# Marketing Bulletin

**PRODUCT:** X-09™, CDX-09 and Cencon

**BULLETIN NUMBER:** MB013

## New Extended Change Key

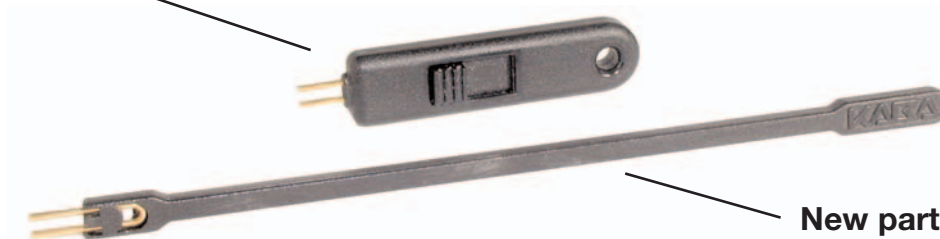
Kaba Mas has redesigned our change key and will begin shipping the new model with each Cencon, X-09 and CDX-09 lock ordered.

- Length is now 5" (127mm), compared with the previous 2" (52mm), allowing easier and quicker access to the back of the lock case.
- Width and depth have been reduced by 50%, allowing more space to work with through the opening in your container's door cover.
- Gold prongs remain permanently extended, preventing the need to keep your thumb on a switch during use.

\*Please note, the previous design of change key will continue to be compatible with existing and new locks. Never insert non-approved items into change key openings of lock. Use of substitute objects with sharp edges or without ESD-protection can damage the electronic card and will void the warranty.
